SERVICE BULLETIN

N° **139-759**

DATE: August 3, 2023

ATA 11 - ADDITIONAL MARKINGS FOR CS26 AMDT 4 KIT INSTALLATION

Figure 2

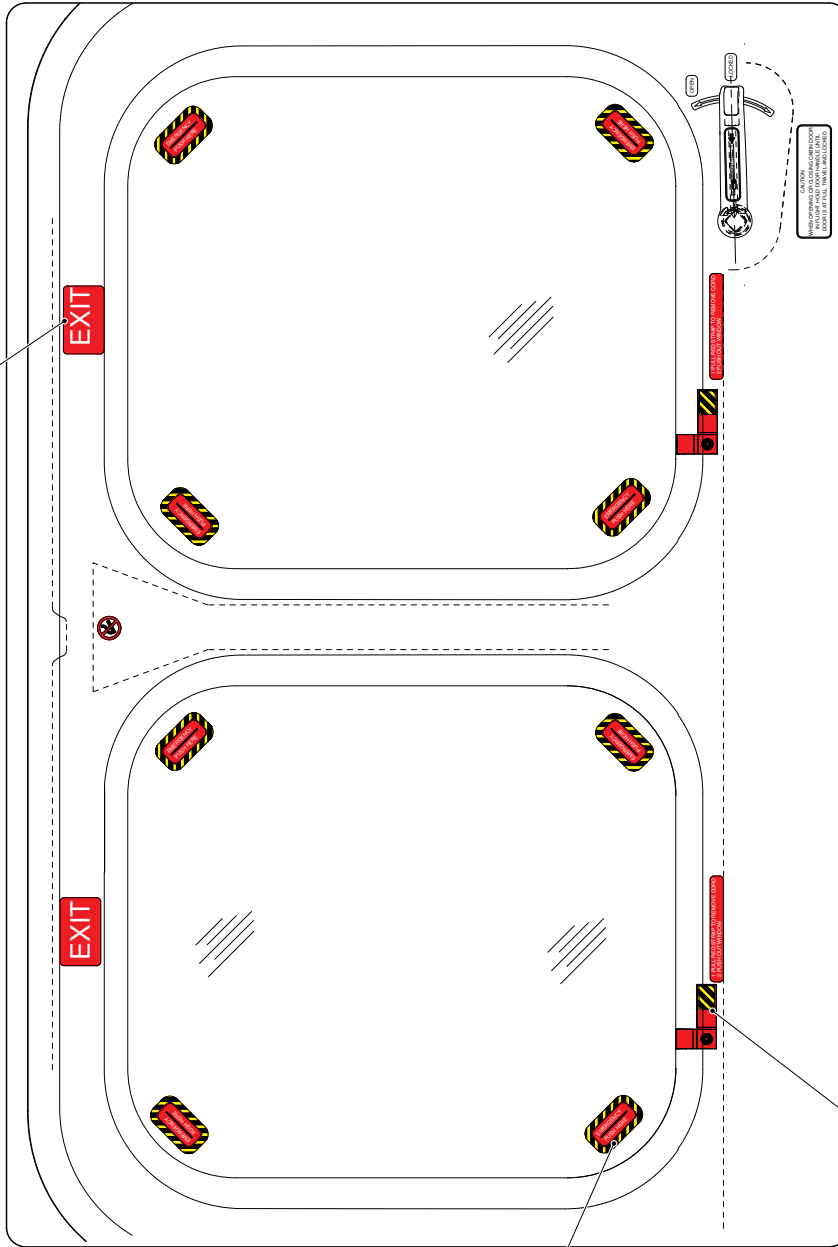
2. With reference to Figure 2 Detail B and Figure 24, sew n°2 decals CS26 pull strap P/N 3G1130A27152 by means of synthetic commercial yarn (colour red, n°31136 per FED-STD-595) on the two strap assemblies P/N A487A003A.

3. In accordance with the applicable steps of AMP DM 39-A-56-32-01-00A-920A-A or 39-A-56-32-02-00A-920A-A or 39-A-56-33-01-00A-920A-K or 39-A-56-33-02-00A-920A-K and with reference to Figure 2 Detail B, from the LH or RH cabin sliding door windows, remove n°2 strap assemblies P/N A487A003A or any other different basic version.
4. In accordance with the applicable steps of AMP DM 39-A-56-32-01-00A-920A-A or 39-A-56-32-02-00A-920A-A or 39-A-56-33-01-00A-920A-K or 39-A-56-33-02-00A-920A-K and with reference to Figure 2 Detail B, install n°2 pull straps CS26 P/N 3G5211A14431 on the LH or RH cabin sliding door windows.

5. In accordance with AMP DM 39-A-11-00-01-00A-720A-A and with reference to Figure 2 Detail B, install n°8 decals P/N 3G1130A27151 on the LH or RH cabin sliding door windows as required.

Figure 3

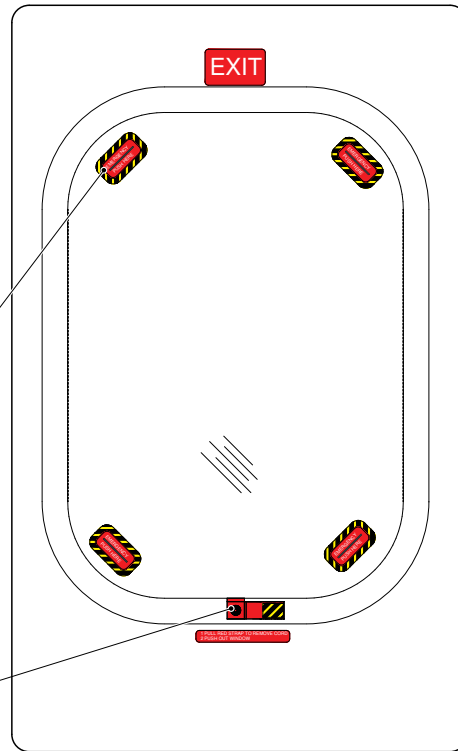
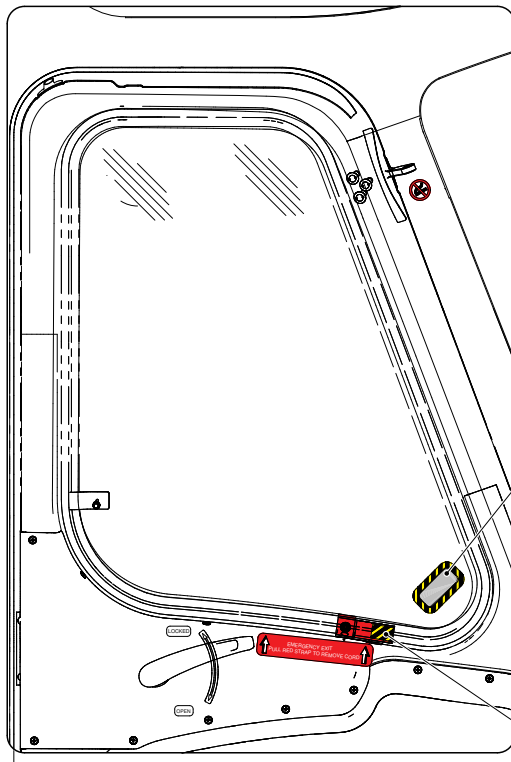
6. With reference to Figure 3 Detail C and Figure 24, sew the decal CS26 pull strap P/N 3G1130A27152 by means of synthetic commercial yarn (colour red, n°31136 per FED-STD-595) on the strap assembly P/N A487A005A.

7. In accordance with the applicable steps of AMP DM 39-A-56-21-01-00A-920A-A or 39-A-56-21-02-00A-920A-A or 39-A-56-23-01-00A-920A-K or 39-A-56-23-02-00A-920A-K and with reference to Figure 3 Detail C, from the LH or RH side wall window, remove the strap assembly P/N A487A005A or any other different basic version.
8. In accordance with the applicable steps of AMP DM 39-A-56-21-01-00A-920A-A or 39-A-56-21-02-00A-920A-A or 39-A-56-23-01-00A-920A-K or 39-A-56-23-02-00A-920A-K and with reference to Figure 3 Detail C, install the pull strap CS26 side wall P/N 3G5211A14432 on the LH or RH side wall window.

9. In accordance with AMP DM 39-A-11-00-01-00A-720A-A and with reference to Figure 3 Detail C, install n°4 decals P/N 3G1130A27151 on the LH or RH side wall window as required.

10. With reference to Figure 3 Detail D and Figure 24, sew the decal CS26 pull strap P/N 3G1130A27152 by means of synthetic commercial yarn (colour red, n°31136 per FED-STD-595) on the strap assembly P/N A487A003A.

11. In accordance with the applicable steps of AMP DM 39-A-56-31-01-00A-920A-A or 39-A-56-31-01-00A-920B-A or 39-B-56-31-01-00A-920A-K or 39-A-56-31-02-00A-920A-A or 39-A-56-31-02-00A-920B-A or 39-B-56-31-02-00A-920A-K and with reference to Figure 3 Detail D, from the LH or RH cockpit door window, remove the strap assembly P/N A487A003A or any other different basic version.

12. In accordance with the applicable steps of AMP DM 39-A-56-31-01-00A-920A-A or 39-A-56-31-01-00A-920B-A or 39-B-56-31-01-00A-920A-K or 39-A-56-31-02-00A-920A-A or 39-A-56-31-02-00A-920B-A or 39-B-56-31-02-00A-920A-K and with reference to Figure 3 Detail D, install the pull strap CS26 P/N 3G5211A14431 on the LH or RH cockpit door window.

13. In accordance with AMP DM 39-A-11-00-01-00A-720A-A and with reference to Figure 3 Detail D, install the decal P/N 3G1130A27151 on the LH or RH cockpit door window as required.
14. Repeat steps 2 thru 13 for the other side of the helicopter.
15. Return the helicopter to flight configuration and record for compliance with Part I of this Service Bulletin on the helicopter logbook.
16. Gain access to My Communications section on Leonardo WebPortal and compile the “Service Bulletin Application Communication”.

Figure 5

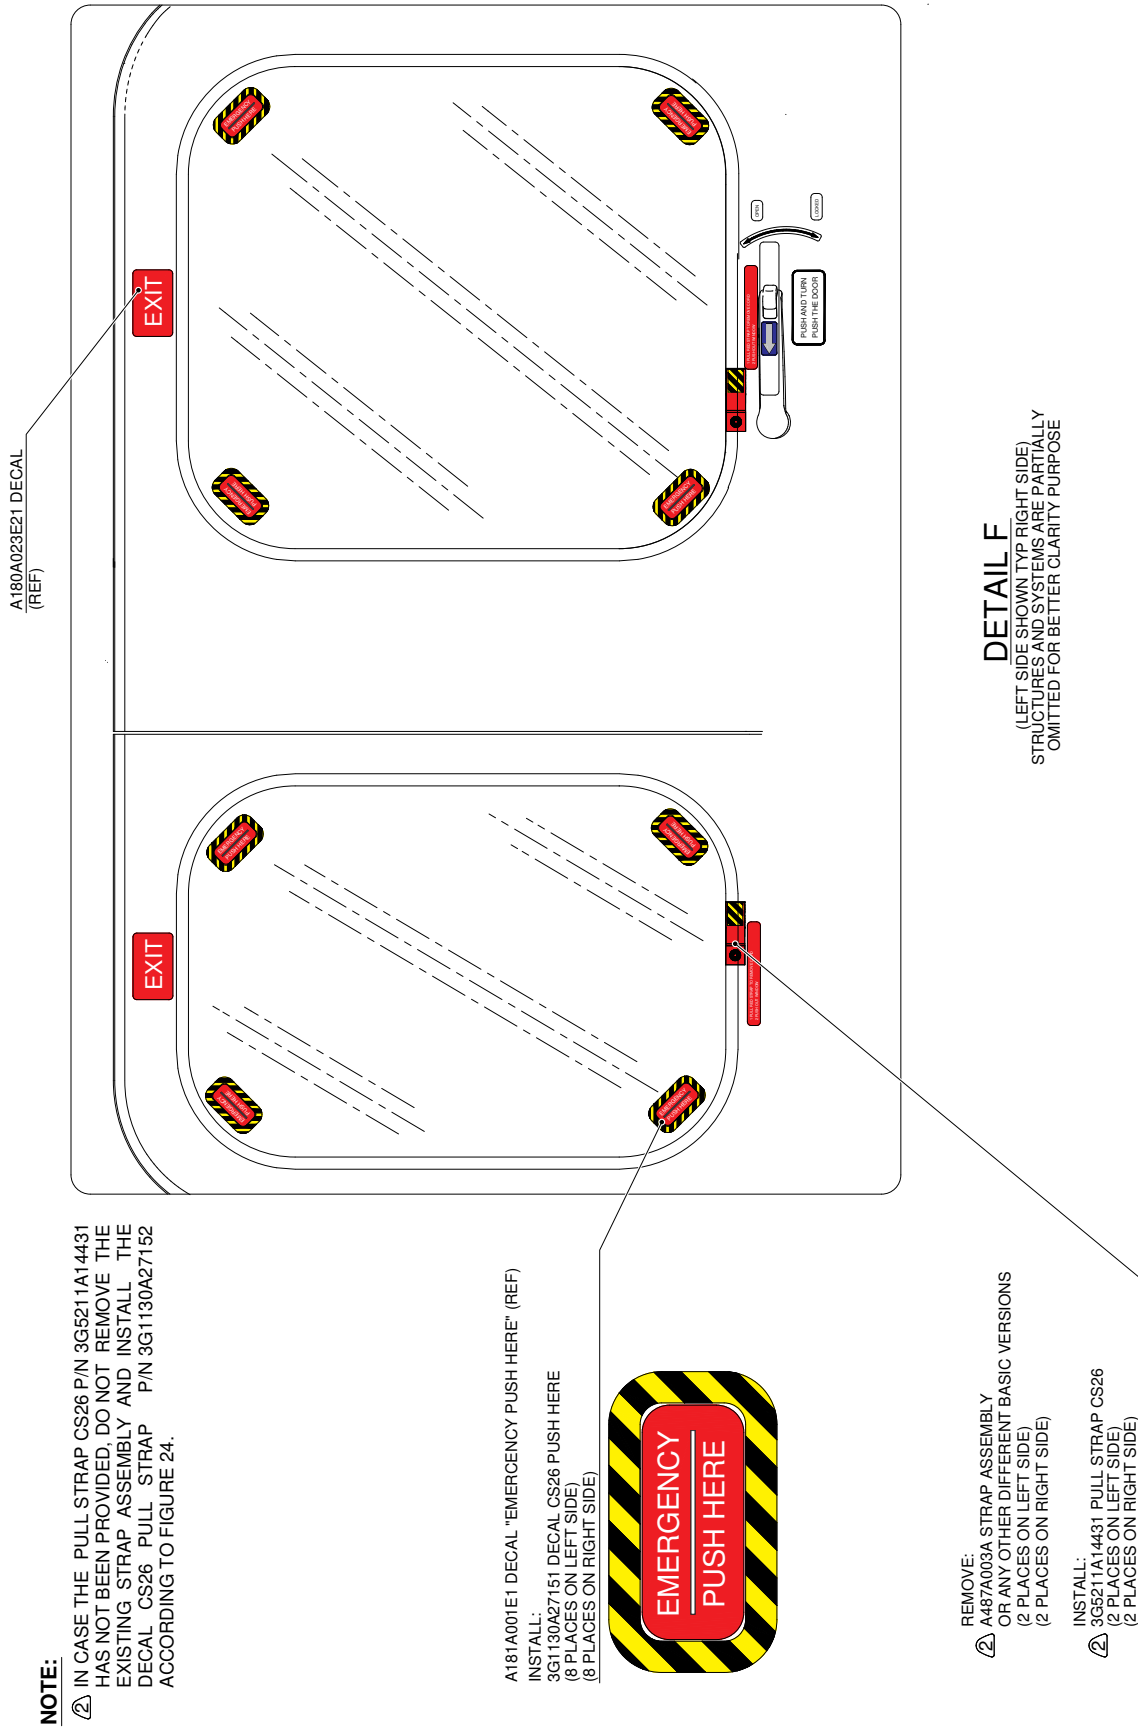
2. With reference to Figures 5 Detail F and Figure 24, sew n°2 decals CS26 pull strap P/N 3G1130A27152 by means of synthetic commercial yarn (colour red, n°31136 per FED-STD-595) on the two strap assemblies P/N A487A003A.

3. In accordance with the applicable steps of AMP DM 39-A-56-32-01-00A-920A-A or 39-A-56-32-02-00A-920A-A or 39-A-56-33-01-00A-920A-K or 39-A-56-33-02-00A-920A-K and with reference to Figure 5 Detail F, from the LH or RH cabin hinged door windows, remove n°2 strap assemblies P/N A487A003A or any other different basic version.

4. In accordance with the applicable steps of AMP DM 39-A-56-32-01-00A-920A-A or 39-A-56-32-02-00A-920A-A or 39-A-56-33-01-00A-920A-K or 39-A-56-33-02-00A-920A-K and with reference to Figure 5 Detail F, install n°2 pull straps CS26 P/N 3G5211A14431 on the LH or RH cabin hinged door windows.

5. In accordance with AMP DM 39-A-11-00-01-00A-720A-A and with reference to Figure 5 Detail F, install n°8 decals P/N 3G1130A27151 on the LH or RH cabin hinged door windows as required.

Figure 6

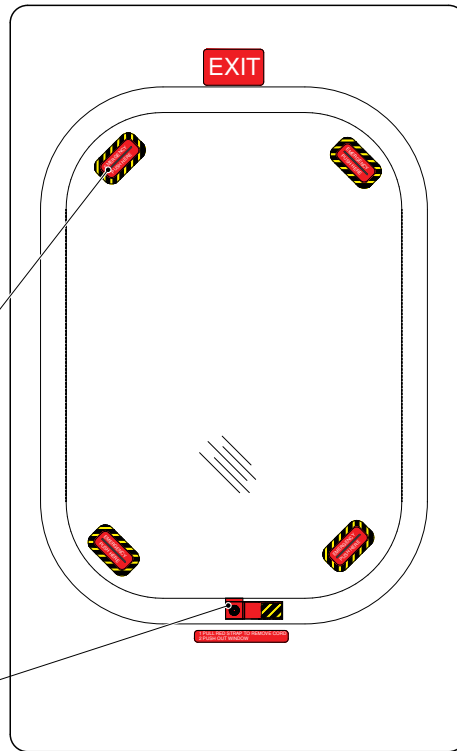
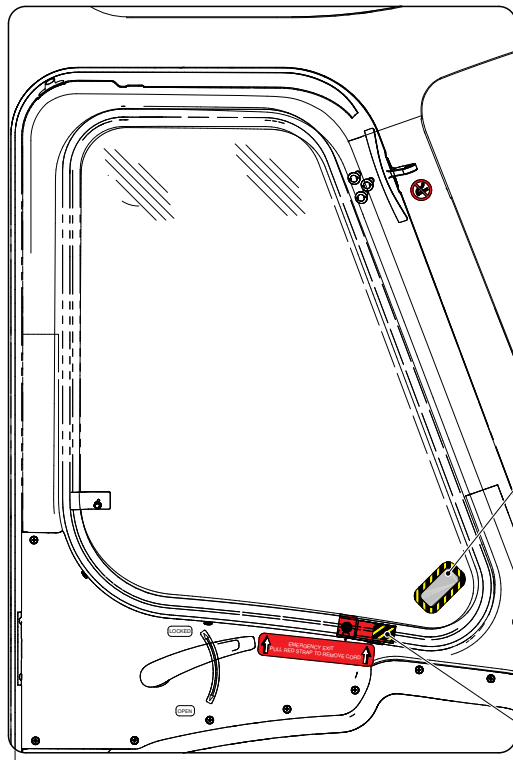
6. With reference to Figure 6 Detail G and Figure 24, sew the decal CS26 pull strap P/N 3G1130A27152 by means of synthetic commercial yarn (colour red, n°31136 per FED-STD-595) on the strap assembly P/N A487A005A.

7. In accordance with the applicable steps of AMP DM 39-A-56-21-01-00A-920A-A or 39-A-56-21-02-00A-920A-A or 39-A-56-23-01-00A-920A-K or 39-A-56-23-02-00A-920A-K and with reference to Figure 6 Detail G, from the LH or RH side wall window, remove the strap assembly P/N A487A005A or any other different basic version.
8. In accordance with the applicable steps of AMP DM 39-A-56-21-01-00A-920A-A or 39-A-56-21-02-00A-920A-A or 39-A-56-23-01-00A-920A-K or 39-A-56-23-02-00A-920A-K and with reference to Figure 6 Detail G, install the pull strap CS26 side wall P/N 3G5211A14432 on the LH or RH side wall window.

9. In accordance with AMP DM 39-A-11-00-01-00A-720A-A and with reference to Figure 6 Detail G, install n°4 decals P/N 3G1130A27151 on the LH or RH side wall window as required.

10. With reference to Figure 6 Detail H and Figure 24, sew the decal CS26 pull strap P/N 3G1130A27152 by means of synthetic commercial yarn (colour red, n°31136 per FED-STD-595) on the strap assembly P/N A487A003A.

11. In accordance with the applicable steps of AMP DM 39-A-56-31-01-00A-920A-A or 39-A-56-31-01-00A-920B-A or 39-B-56-31-01-00A-920A-K or 39-A-56-31-02-00A-920A-A or 39-A-56-31-02-00A-920B-A or 39-B-56-31-02-00A-920A-K and with reference to Figure 6 Detail H, from the LH or RH cockpit door window, remove the strap assembly P/N A487A003A or any other different basic version.
12. In accordance with the applicable steps of AMP DM 39-A-56-31-01-00A-920A-A or 39-A-56-31-01-00A-920B-A or 39-B-56-31-01-00A-920A-K or 39-A-56-31-02-00A-920A-A or 39-A-56-31-02-00A-920B-A or 39-B-56-31-02-00A-920A-K and with reference to Figure 6 Detail H, install the pull strap CS26 P/N 3G5211A14431 on the LH or RH cockpit door window.

13. In accordance with AMP DM 39-A-11-00-01-00A-720A-A and with reference to Figure 6 Detail H, install the decal P/N 3G1130A27151 on the LH or RH cockpit door window as required.
14. Repeat steps 2 thru 13 for the other side of the helicopter.
15. Return the helicopter to flight configuration and record for compliance with Part II of this Service Bulletin on the helicopter logbook.

Figure 8

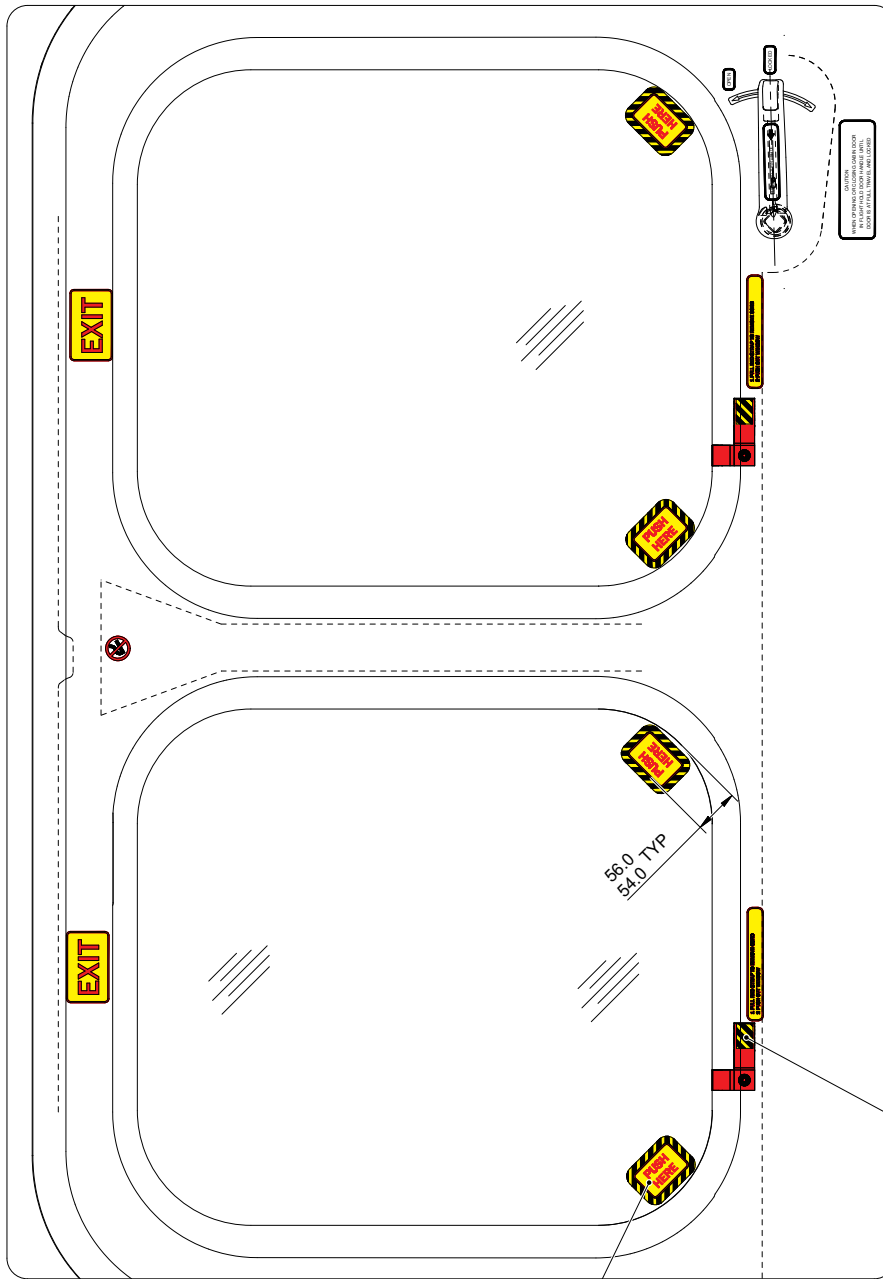
- 2.1 With reference to Figure 8 Detail B and Figure 24, sew n°2 decal CS26 pull straps P/N 3G1130A27152 by means of synthetic commercial yarn (colour red, n°31136 per FED-STD-595) on the two strap assemblies P/N A487A003A.

- 2.2 In accordance with the applicable steps of AMP DM 39-A-56-32-01-00A-920A-A or 39-A-56-32-02-00A-920A-A or 39-A-56-33-01-00A-920A-K or 39-A-56-33-02-00A-920A-K and with reference to Figure 8 Detail B, from the LH or RH cabin sliding door windows, remove n°2 strap assemblies P/N A487A003A or any other different basic version.
- 2.3 In accordance with the applicable steps of AMP DM 39-A-56-32-01-00A-920A-A or 39-A-56-32-02-00A-920A-A or 39-A-56-33-01-00A-920A-K or 39-A-56-33-02-00A-920A-K and with reference to Figure 8 Detail B, install n°2 pull straps CS26 P/N 3G5211A14431 on the LH or RH cabin sliding door windows.

- 2.4 In accordance with AMP DM 39-A-11-00-01-00A-720A-A and with reference to Figure 8 Detail B, install n°4 decals P/N 3G1130A27153 on the LH or RH cabin sliding door windows as required.

Figure 9

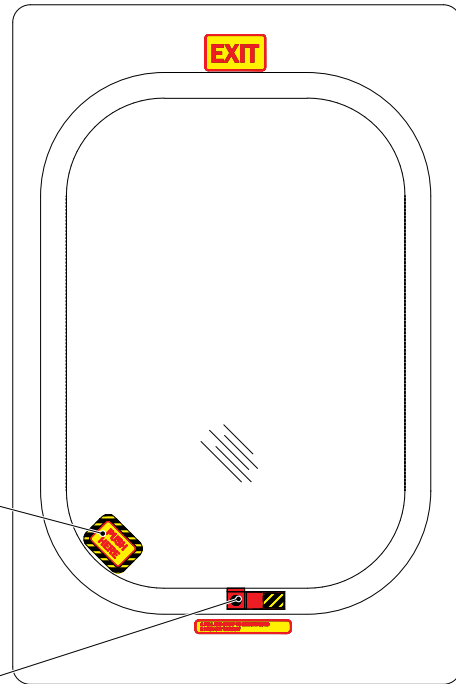
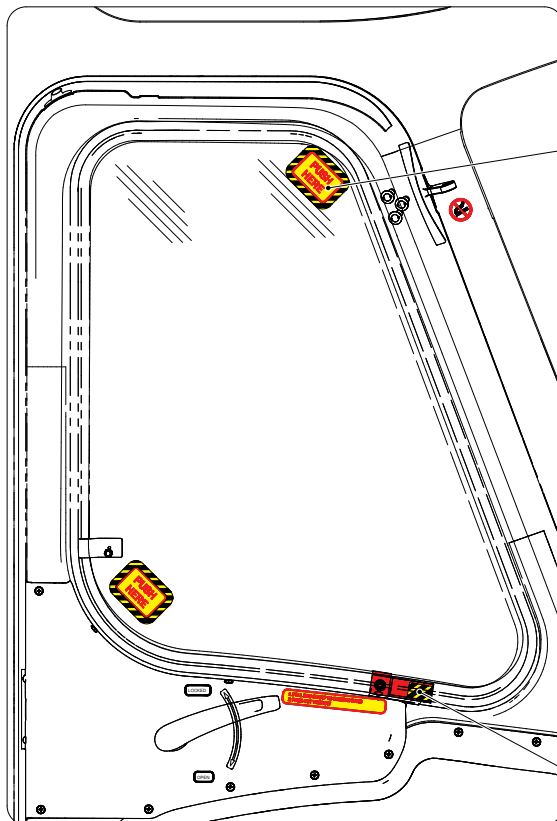
- 2.5 With reference to Figure 9 Detail C and Figure 24, sew the decal CS26 pull strap P/N 3G1130A27152 by means of synthetic commercial yarn (colour red, n°31136 per FED-STD-595) on the strap assembly P/N A487A005A.

- 2.6 In accordance with the applicable steps of AMP DM 39-A-56-21-01-00A-920A-A or 39-A-56-21-02-00A-920A-A or 39-A-56-23-01-00A-920A-K or 39-A-56-23-02-00A-920A-K and with reference to Figure 9 Detail C, from the LH or RH side wall window, remove the strap assembly P/N A487A005A or any other different basic version.
- 2.7 In accordance with the applicable steps of AMP DM 39-A-56-21-01-00A-920A-A or 39-A-56-21-02-00A-920A-A or 39-A-56-23-01-00A-920A-K or 39-A-56-23-02-00A-920A-K and with reference to Figure 9 Detail C, install the pull strap CS26 side wall P/N 3G5211A14432 on the LH or RH side wall window.

- 2.8 In accordance with AMP DM 39-A-11-00-01-00A-720A-A and with reference to Figure 9 Detail C, install the decal P/N 3G1130A27153 on the LH or RH side wall window as required.

- 2.9 With reference to Figure 9 Detail D and Figure 24, sew the decal CS26 pull strap P/N 3G1130A27152 by means of synthetic commercial yarn (colour red, n°31136 per FED-STD-595) on the strap assembly P/N A487A003A.

- 2.10 In accordance with the applicable steps of AMP DM 39-A-56-31-01-00A-920B-A or 39-B-56-31-01-00A-920A-K or 39-A-56-31-02-00A-920B-A or 39-B-56-31-02-00A-920A-K and with reference to Figure 9 Detail D, from the LH or RH cockpit door window, remove the strap assembly P/N A487A003A or any other different basic version.
- 2.11 In accordance with the applicable steps of AMP DM 39-A-56-31-01-00A-920B-A or 39-B-56-31-01-00A-920A-K or 39-A-56-31-02-00A-920B-A or 39-B-56-31-02-00A-920A-K and with reference to Figure 9 Detail D, install the pull strap CS26 P/N 3G5211A14431 on the LH or RH cockpit door window.

- 2.12 In accordance with AMP DM 39-A-11-00-01-00A-720A-A and with reference to Figure 9 Detail D, install n°2 decals P/N 3G1130A27153 on the LH or RH cockpit door window as required.
- 2.13 Repeat steps 2.1 thru 2.12 for the other side of the helicopter.
3. With reference to Figures 13 and 14, perform the external mark installation CS26 push here yellow P/N 3G1120A16811 as described in the following procedure:
